SUBJECT : Evaluation of the 35mm Time Lapse Camera

MEMORANDUM FOR THE RECORD**SUBJECT: Evaluation of the 35mm Film Lapco Camera**

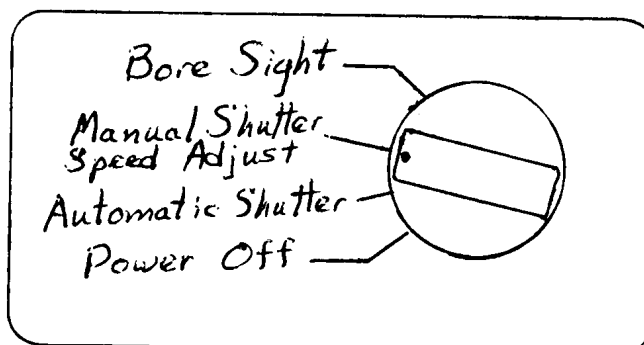
- (a) The frame sight on top of the camera is good; however, there is some confusion about which front frame to use when the rear sight has been positioned to correspond with a lens length. If the lens size and its reference line were placed on the same side of the scale, and the scales for the long and short lenses were placed one on each side of the slide track, the correct procedure would be more obvious.
- (b) It is realized that the method of boresighting is difficult to use (particularly where the camera is mounted in an awkward position or must not be moved after aiming) and also that there are extreme space limitations between the film plane and the rear element of the 1" lens. For these reasons a compromise between the present system and permanent reflex viewer seems advisable. This is discussed in the following section "(c)".

- (1) The reflex device provided can not be secured rigidly or accurately to the camera body. A track for the existing tabs would help.
- (2) The boresight button is tiring to hold down due to its small size. A lock-down feature would be desirable under some operating circumstances.
- (c) If a complete set of lenses are to be supplied with the camera, it should be practical to modify the longer ones to accept a reflex device. Since the short lenses have a wider field of view, the camera does not need to be aimed as accurately, thus a conventional viewfinder (similar to the one provided on the camera) should suffice.

This may not be the best solution, but some simplified sighting method should be incorporated to reduce number of operations presently required.
